# PCN for Mighty Mini Fan

- Entry gate control will phase in-
- From August.1 , 2018)

## Change Description/調整描述 – Mighty Mini Fan

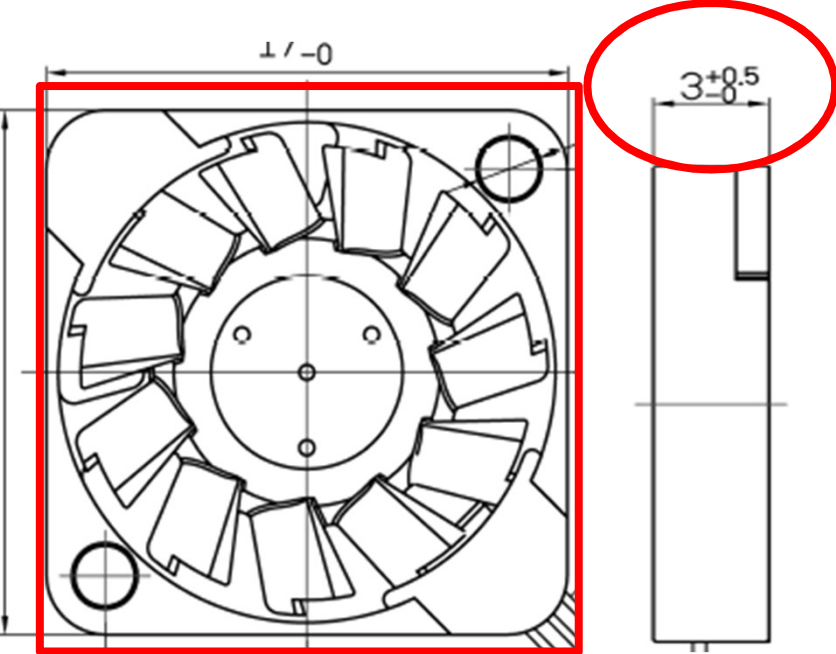
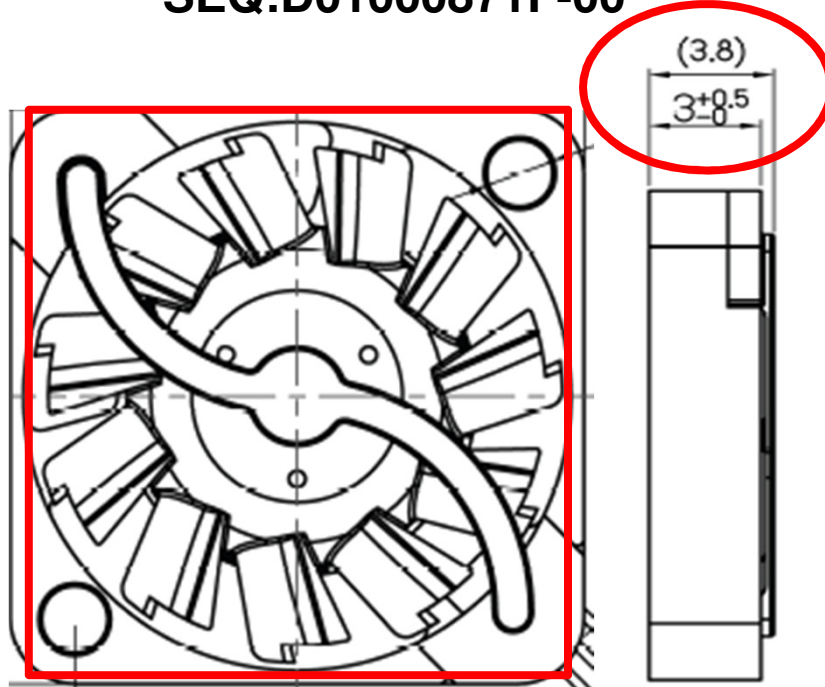
**Part of dimension increased, thickness 3.8mm instead of 3.4mm and others are no change. (Please refer page 7.)**

### Example : DIMENSION OF Data Sheet

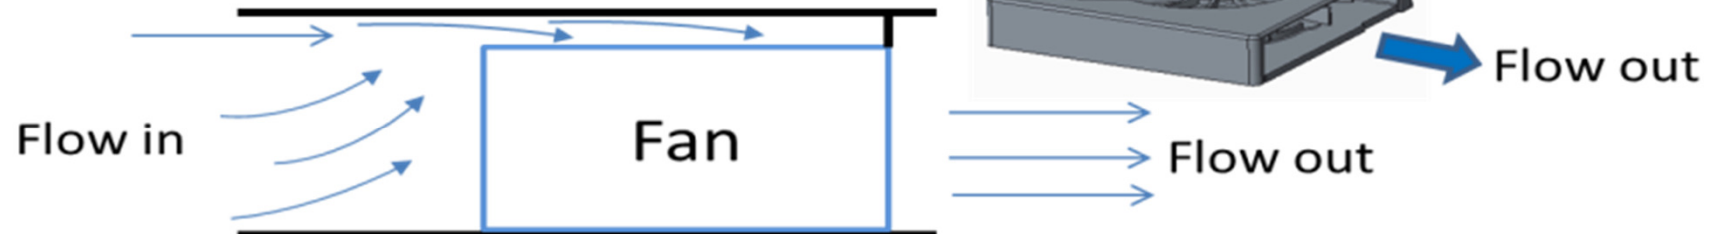
Before	After
<p>PN:UF3H3-700 SEQ:D01000871F-00</p> 	<p>PN:UF3H3-700 SEQ:D01000871F-00</p>
